Subject: NRC Request for Additional Information (TAC
No. MD3410) dated July 1, 2008.

Docket No. 50-184

NIST Response to NRC Request for Information (TAC No. MD3410), August 19, 2008

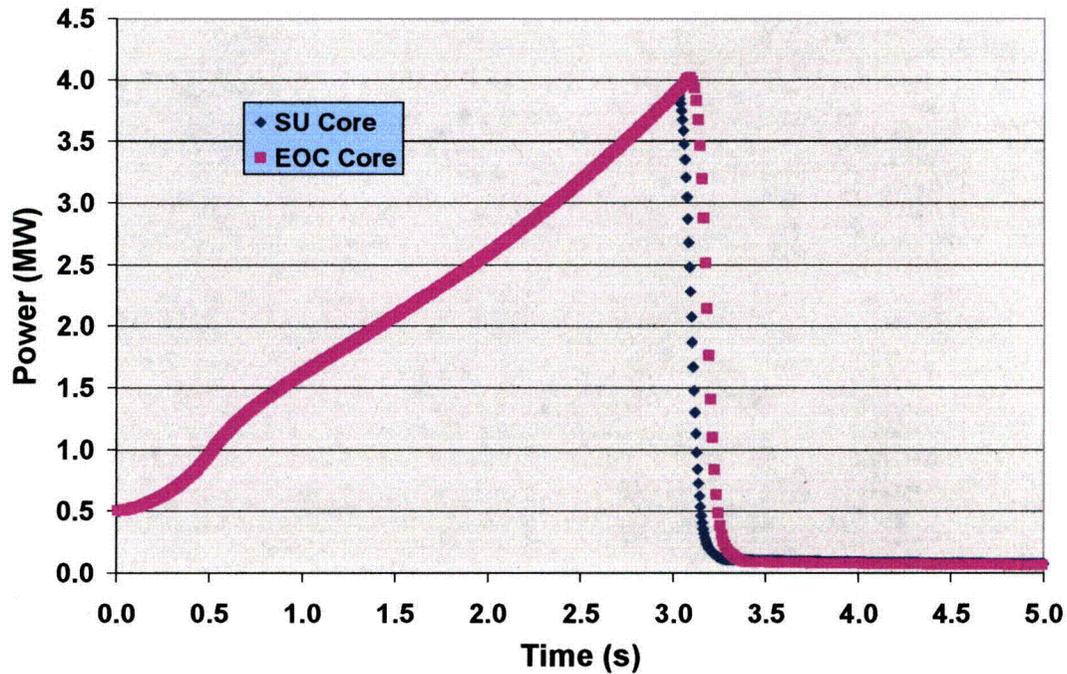
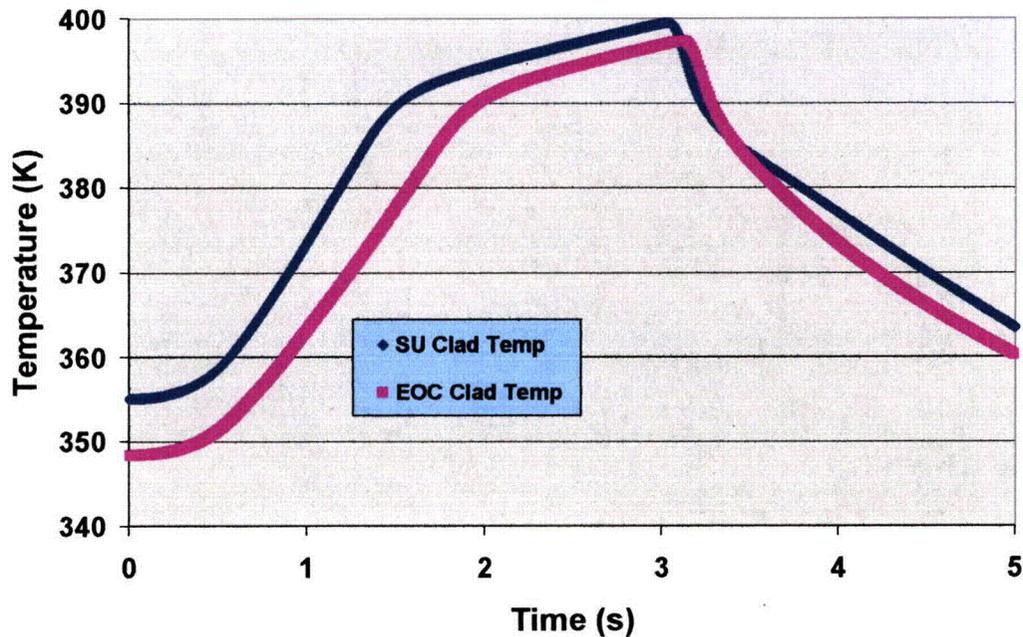
4.1 Section 4.6, Thermal hydraulic Design & TS 2.2, LSSS. Provide justification for 500 kW power operations under natural convection flow by demonstrating that no credible accidents would result in exceeding the safety limit. (See TS question 2.2)

The only credible accidents for this case where there is no forced flow are those initiated by reactivity insertion. Therefore, we have analyzed both the maximum reactivity insertion and startup accidents for natural circulation. In this case, the best measure of the safety margin is the clad temperature, rather than the CHFR, because flow can oscillate during the excursion. These excursions are initiated exactly as in the forced flow case, and are terminated by the period scram, which is tripped when the period decreases below 5 s. For conservatism, a 3-s delay between reaching the trip point and actual trip initiation is assumed. In Table 1 below, the results for both initiation sequences are shown for both Startup (SU) and End of Cycle (EOC) cores.

These results show that the maximum fuel clad temperature is 400 K for the maximum reactivity insertion accident with the startup core, which is much less than the safety limit of 723 K (450 °C). The evolution of the maximum

reactivity insertion accident is shown in Figures 1 and 2 below. Note that the value of the maximum temperature is dominated by the 3-s delay.

This analysis shows that there is ample margin between the maximum clad temperature in any credible accident and the safety limit of 450 °C.

Figure 3. Comparison of the LSSS power limit as a function of flow with the maximum allowed power before either OFI, ONVG, or CHF.

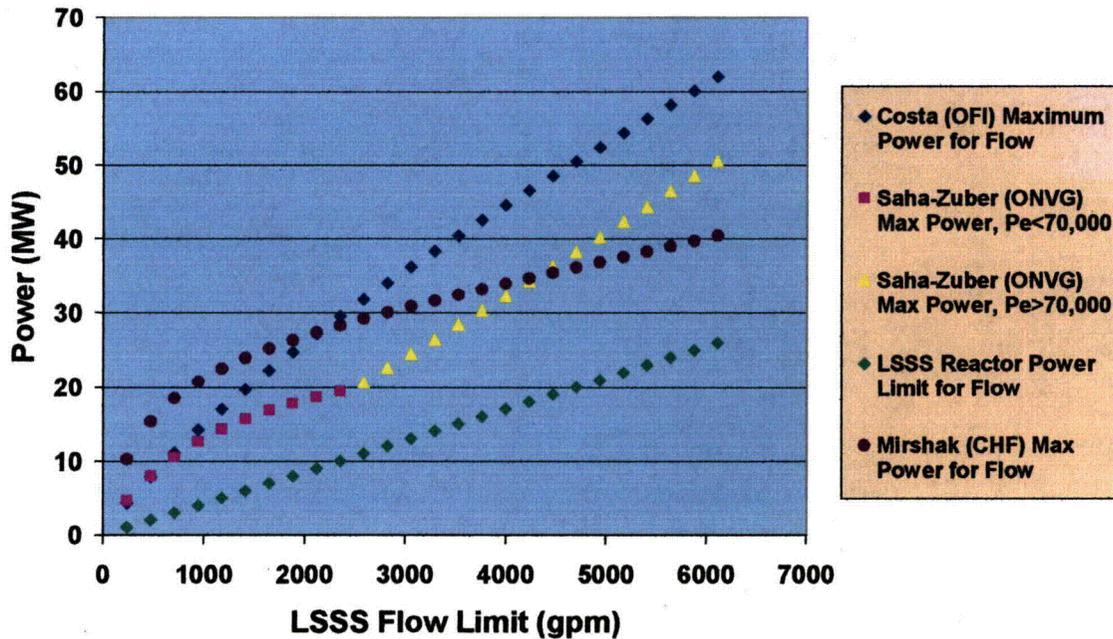
4.2. Section 4.6, Thermal Hydraulic Design, p.4-49. Provide justification that the Costa correlation is the appropriate and limiting method for calculating the critical heat flux given the coolant pressure found in the NBSR fuel channels.

The Costa correlation for the Onset of Flow Instability (OFI) was chosen for the analysis because it had been used in both the ILL reactor and the HFIR

reactor. Although the minimum pressure studied in the derivation of the correlation was 1.75 bar, while the pressure in the NBSR is of order 1.3 bar, there is no reason to expect a large change in physical behavior at the lower pressure. The pressure enters the correlation through the pressure dependence of the saturation temperature, and this quantity varies smoothly between 1.3 and 1.75 bars. A factor of 1.3 was used with the Costa correlation to account for possible errors. In order to check this correlation, we have redone the analysis using the Saha-Zuber correlation¹, which relates to the onset of net vapor generation (ONVG), which is considered a precursor of instability. This was also the point used by Costa to identify the onset of flow instability. Both correlations were developed using circular and rectangular flow channels, but the subsequent analysis was quite different for the two cases.

In order to study and compare the predictions of the two correlations, we have studied the predictions for the case where the outlet temperature of the water is fixed at the LSSS of 147 °F, and the flow is varied up to approximately 8000 gpm total, or 6000 gpm for the outer plenum and 1600 gpm for the inner plenum. At each flow, the inlet temperature for the power corresponding to the LSSS for flow is calculated, and the predictions of the two models are calculated, along with the critical heat flux, calculated using the Mirshak correlation. At each flow, the actual limit occurs in the outer plenum, and therefore, this is the result plotted in Figure 3 below.

The first point that should be noted is that a safety factor of 1.3 is included in all plotted results to allow for the uncertainties in the correlations. The Saha-Zuber correlation predicts a lower power limit over almost the entire range; however, the difference between the two predictions is within the estimated combined uncertainty of the correlations. This result shows that the LSSS proposed are very conservative relative to either correlation. It should also be noted that the Onset of Net Vapor Generation, which is taken as the basis for both correlations, is an ill-defined quantity, determined in quite different ways in the derivation of the two correlations. ONVG is a *precursor* of flow instability, giving added conservatism to the settings.

Figure 4. Maximum reactivity insertion excursion.

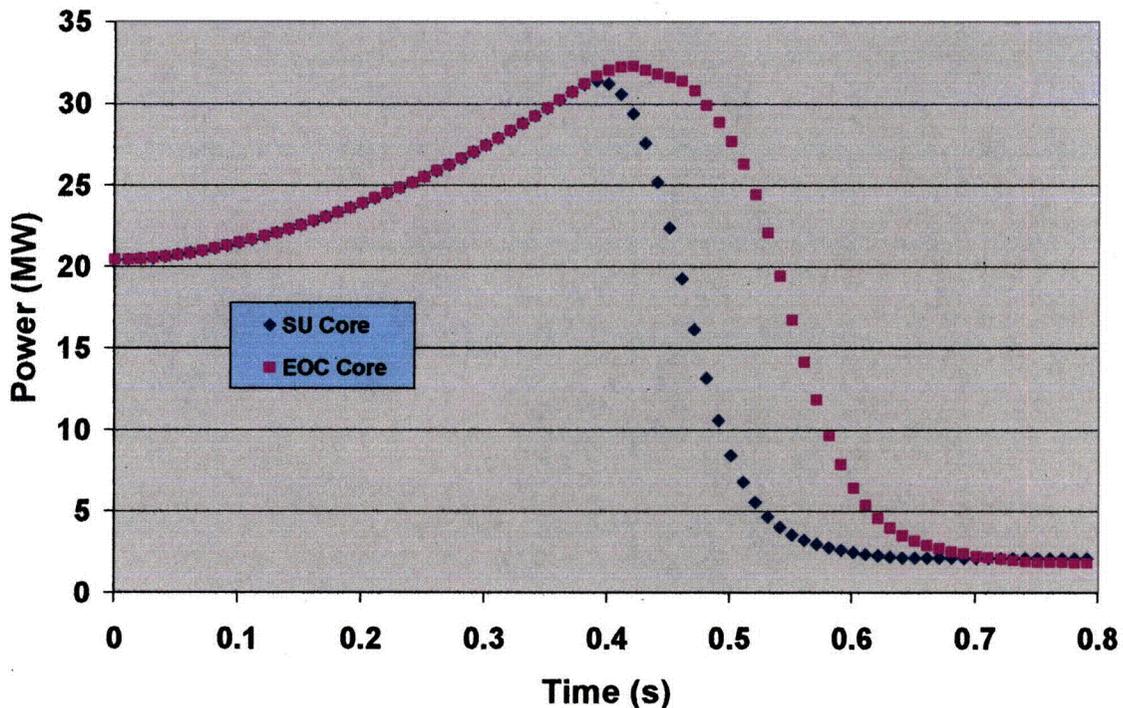
13.1 Section 13.2.2.2.2, Rapid Removal of Experiments, p. 13.9. Please explain the result of minimum CHF at BOC in the new analysis for the ramp reactivity insertion versus the EOC minimum CHF for the previous analysis. Please explain the differences in the initial CHF for the two analyses, original analysis for FSAR submitted with the renewal application dated April 9, 2004, and new analysis submitted by letter dated October 2, 2006.

The minimum CHF is determined by both the maximum reactor power during the excursion and the maximum peaking factor within the core. The former is highest for the EOC because of the lower differential reactivity worth of the shim arms, while the latter is highest for the SU core, when the power is concentrated in the bottom half of the core. In the case of the excursion resulting from removal of experiments, the former dominates for

an excursion at 2.6 % $\Delta\rho$ /s, so that the EOC case is limiting. However, when the reactivity insertion is slower, as in the modified experiment removal (1 % $\Delta\rho$ /s), the latter is determining, and the limiting case occurs for the startup core.

When the new analysis for the changed maximum reactivity accident was performed, the problems with RELAP had just been determined. As a result, the input files had to be rewritten to accommodate the work-around using MATLAB calculations of transient power. During this process, the starting power for the transient was inadvertently changed from 20.4 MW to 20 MW, resulting in the 2% increase in minimum CHF shown in the October 2 submittal. This discrepancy has only a minor effect on the outcome, but the analysis has been repeated using exactly the same parameters as were used for the original SAR, as shown below. The corrected figures and tables will be inserted into the revised SAR.

Figure 5. Step reactivity insertion of 0.2 % $\Delta\rho$ (maximum reactivity of any allowed sample in a rabbit), which should be compared to maximum reactivity insertion excursion which is limiting.

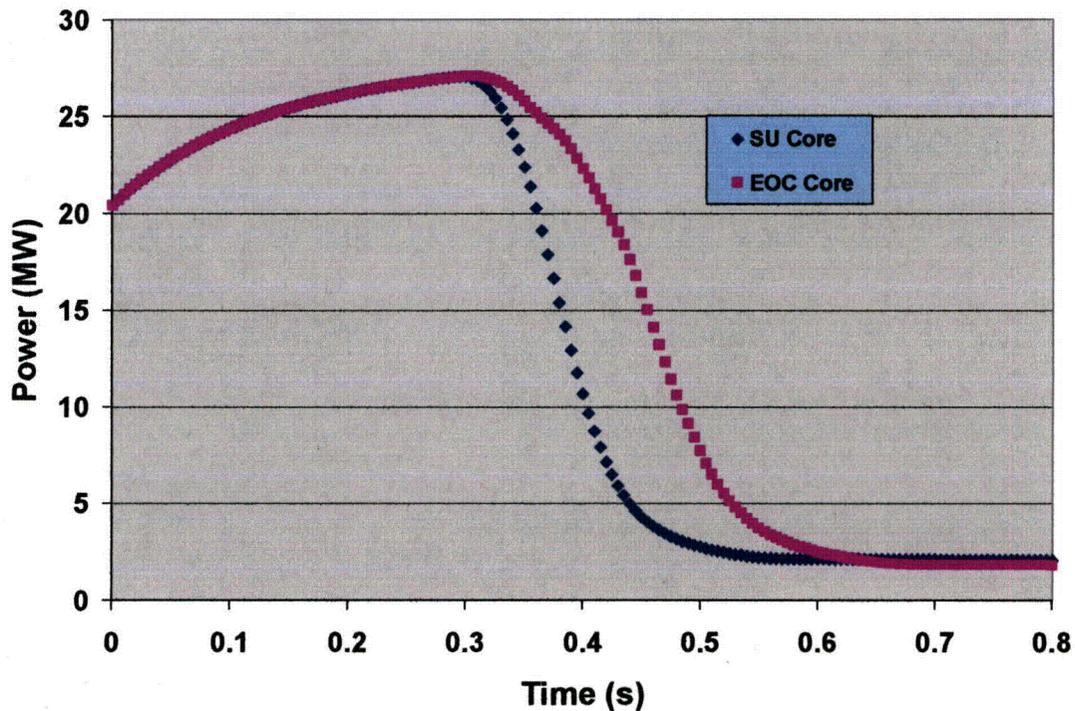
3.8.1(1) Basis (2) of proposed TS 3.8.1 states that the maximum allowed reactivity for the pneumatic irradiation system is 0.2% $\Delta\rho$. Provide discussion and/or analysis that demonstrate(s) that the maximum rate of reactivity addition possible with the pneumatic irradiation system is bounded by the analysis of a ramp insertion of 0.5% $\Delta\rho$ in 0.5 seconds.
